EAST TOWN CROSSING

The submitted civil plans contain review comments ("markups") that must be addressed prior to landuse approval as well as informational comments that can be addressed at time of civil application. Please refer to the DRT Letter "Action Items" for markups that must be addressed for landuse approval. [Prelim. Civil Dwg Part 2, Pg 1 of 15]

EAST TOWN CROSSING SEC. 26,35/ TWP. 20 N./ RGE. 4 E., W.M. PIONEER WAY E. FRONTAGE STORM PLAN

SEC. 26,35/ TWP. 20 N./ RGE. 4 E., W.M. PIONEER WAY E. FRONTAGE STORM PLAN

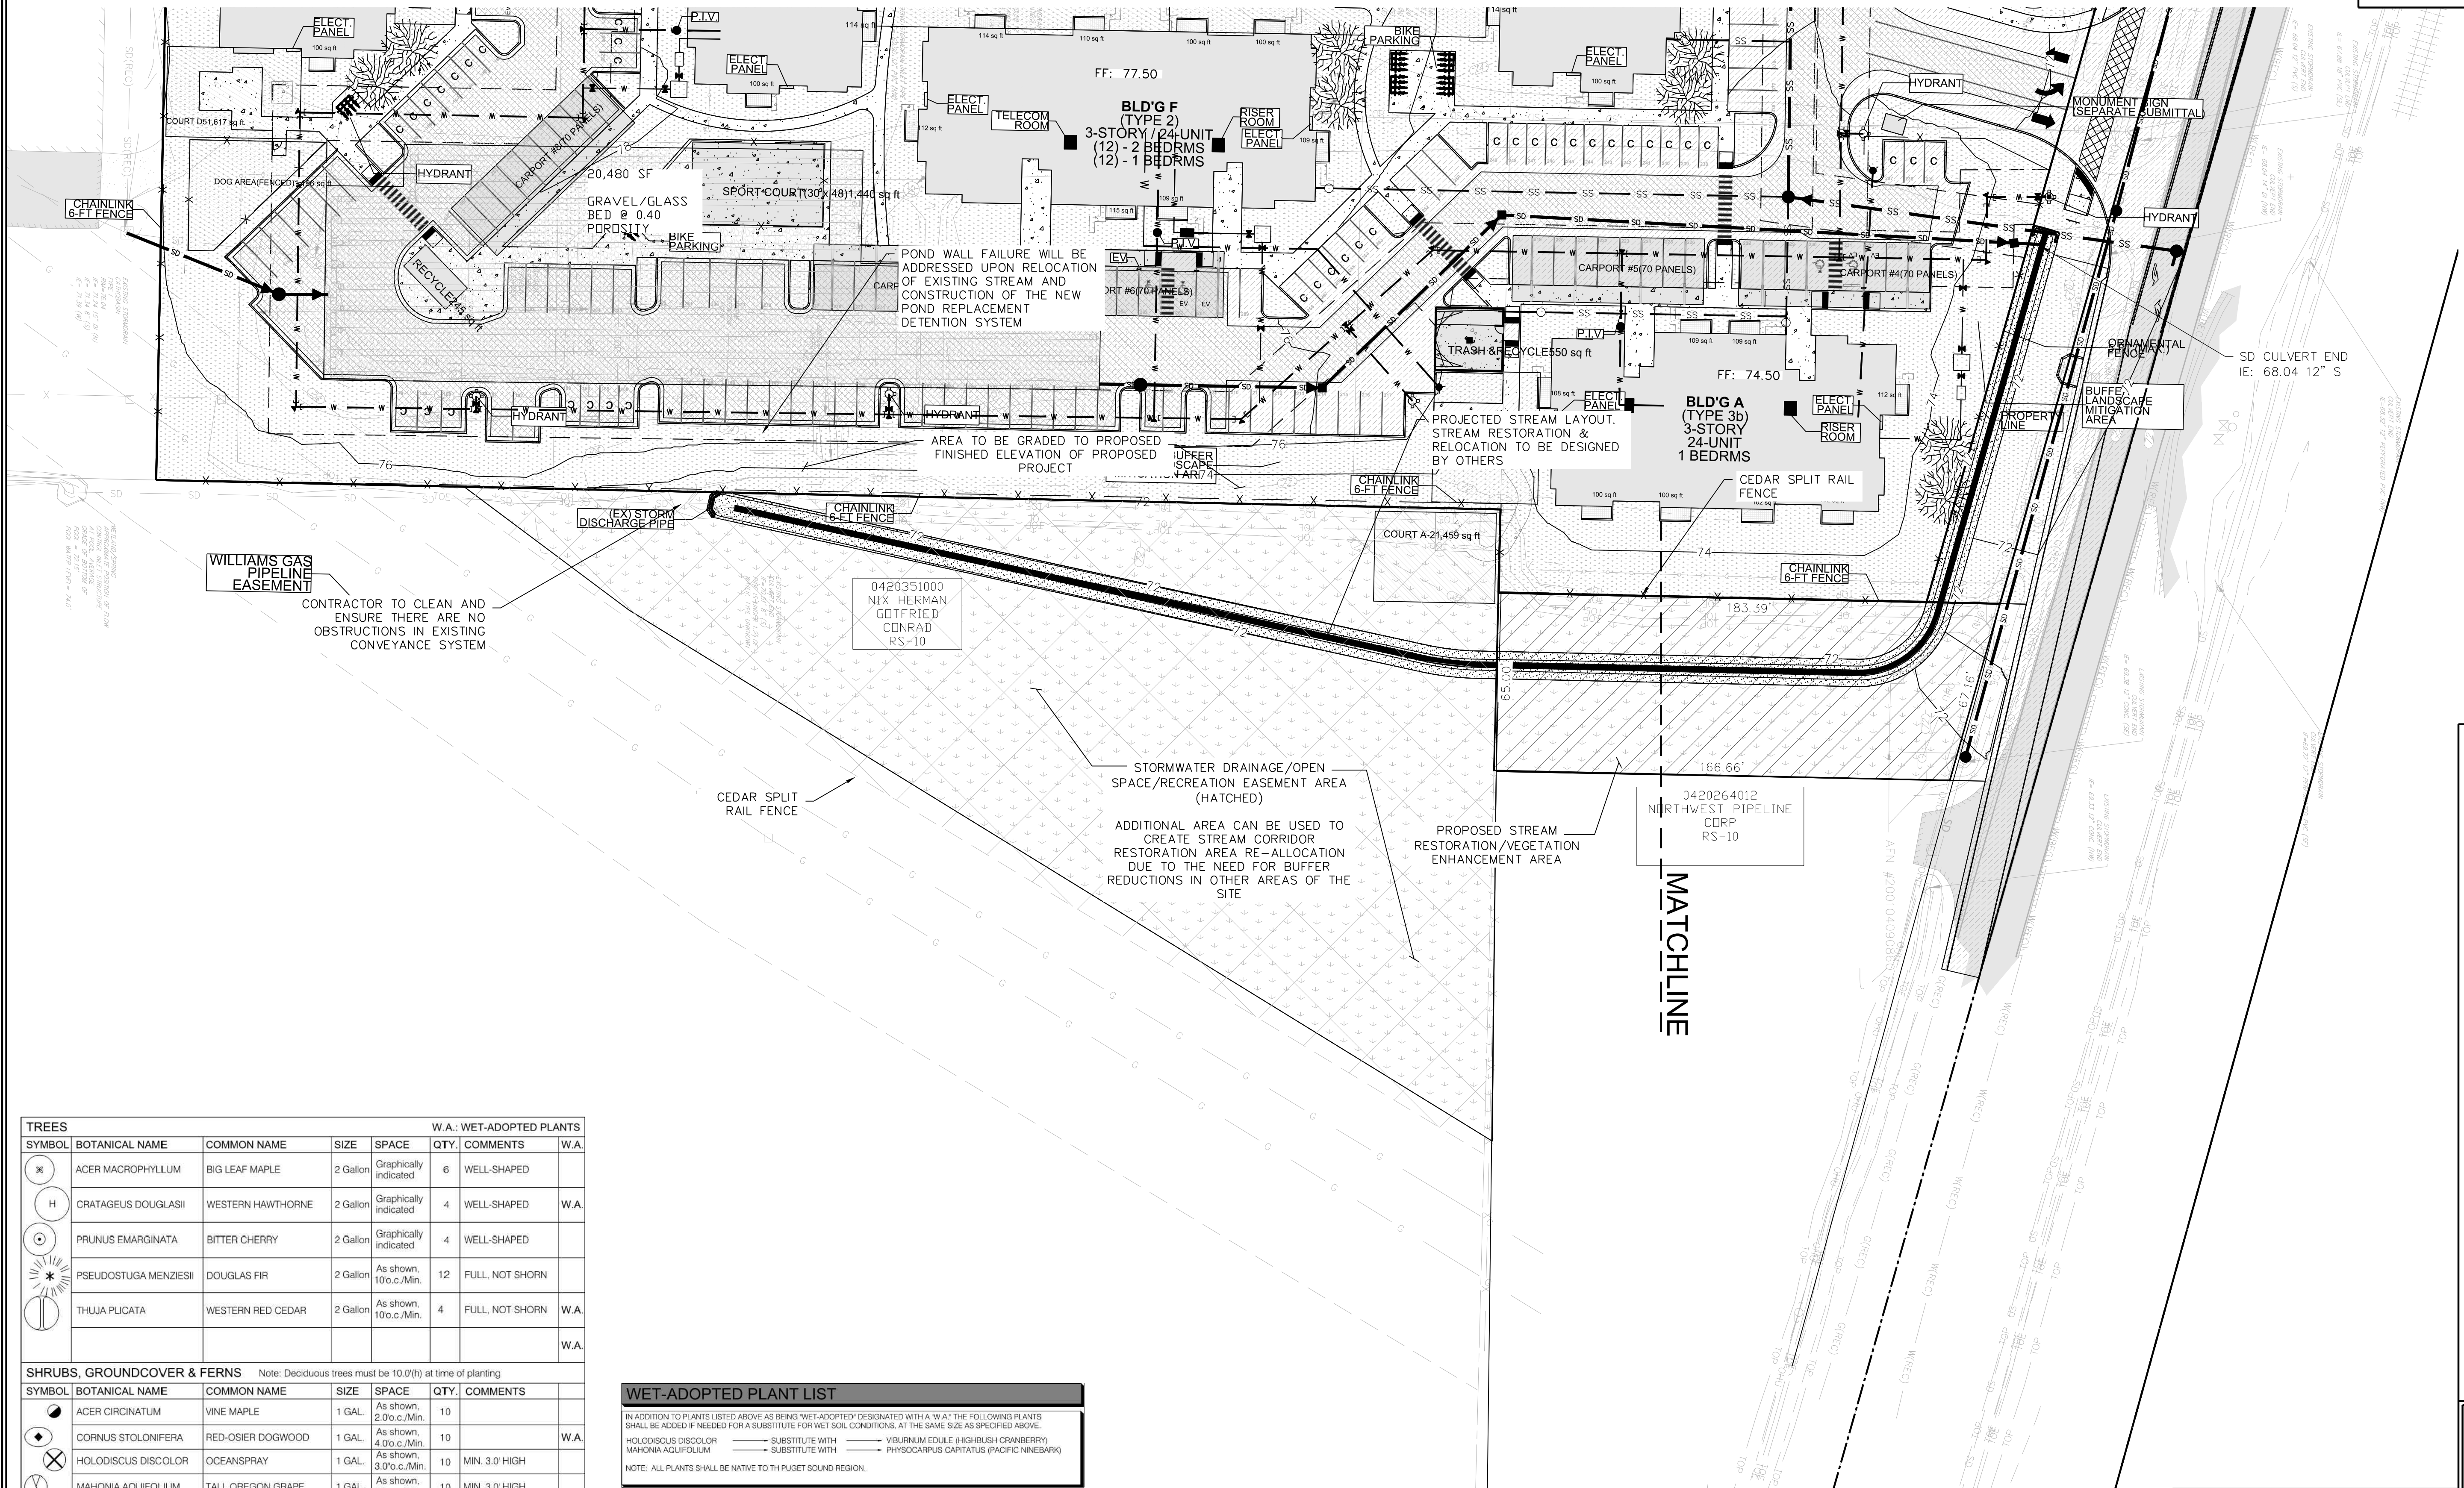
See prior review comments in the Preliminary Storm Report dated December 15, 2021, DRT letter dated May 6, 2022, DRT letter dated August 18, 2022, prior plan markups, and the Pioneer Frontage Plan in Part 4 of this submittal for requested frontage revisions and alignment. (Prelim. Civil Dwg Part 2, Pioneer Frontage Storm Plan, Pg 5 of 15)
